# Proposed Changes to NIE Networks After Diversity Maximum Demand Design Criteria

Decision Paper

September 2023

Figure 1: Consultation Paper Proposed ADMDs & Decision Paper ADMD

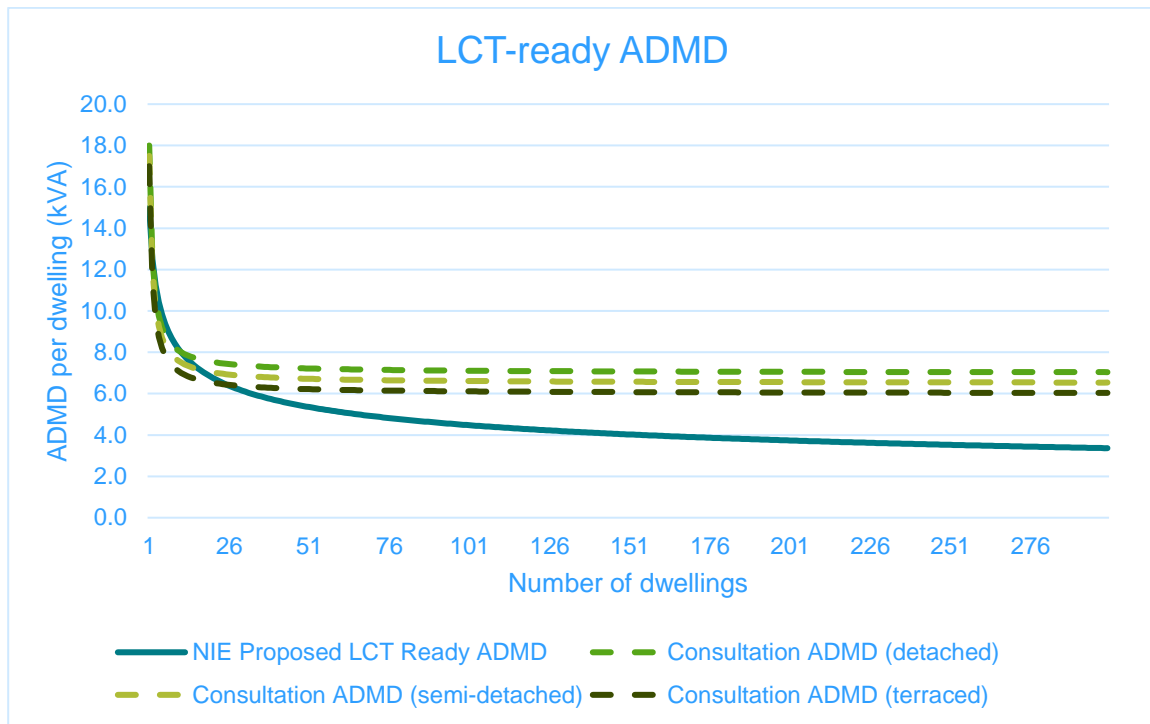
The majority of respondents supported the proposal however some responses questioned the ADMD values noting further advancements of technology with PV and battery storage highlighted.

With consideration to the responses NIE Networks reviewed the impact PV and battery storage may have on demand. We have concluded that that PV and battery storage is likely to reduce domestic demand at certain times particularly during the summer, but that it is likely to have limited impact during the winter peak. The LCT-ready ADMD value proposed will have the inherent benefit of creating additional generation capacity on new LV networks, supporting the installation of PV and battery storage in future. In addition, NIE Networks reviewed proposals by specialist energy consultants with regards to ADMD with LCTs, and in particular potential diversity of demand usage as customer numbers increase. These indicate that increasing customer numbers on the LV Network should increase diversity and in turn decrease LCT ADMD. In recognition of these developments NIE Networks has amended the proposed LCT-ready ADMD to reflect increasing diversity for LCT demand as customer volumes increase.

NIE Networks has rationalised the LCT-ready ADMD from a range of house types to a single LCT-ready ADMD for a domestic connection. We believe this is a reasonable approach to simplifying network modelling as:

Figure 1 shows the LCT-ready ADMD NIE Networks shall implement along with the three ADMD values in the consultation paper. As previously outlined this accounts for an increase in diversity across connected customers and a corresponding lower ADMD at higher customer numbers.
